**COUNTY OF ALBEMARLE**  
**Department of Community Development**  
401 McIntire Road, North Wing  
Charlottesville, Virginia 22902-4596

March 7, 2016

RE: Review Comments on ZMA201200007 – 5<sup>th</sup> Street Commercial and SP201300027 – 5<sup>th</sup> Street Development Drive-Thru

## FEMA LOMR 08-13-1390P

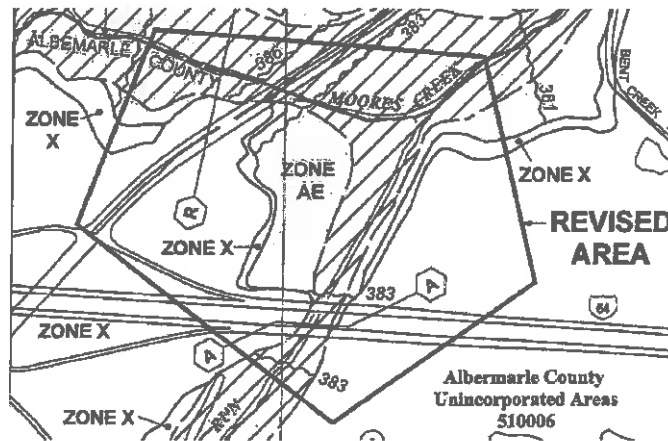
provided John McNair  
plan, dated 4/29/2002,  
"proposed FEMA 100-  
limit" that appears to  
contingent upon the  
proposed with that

plan. Your new plan, dated 3/9/2015, shows what appears to be the same floodplain limits, labeled as "approved 100' year floodplain per approved FEMA map revision". This floodplain limit does not appear to be consistent with the FEMA LOMR dated 8/8/2008 (below). When/how were the floodplain limits you're showing approved? Is there a more recent LOMR for this area?
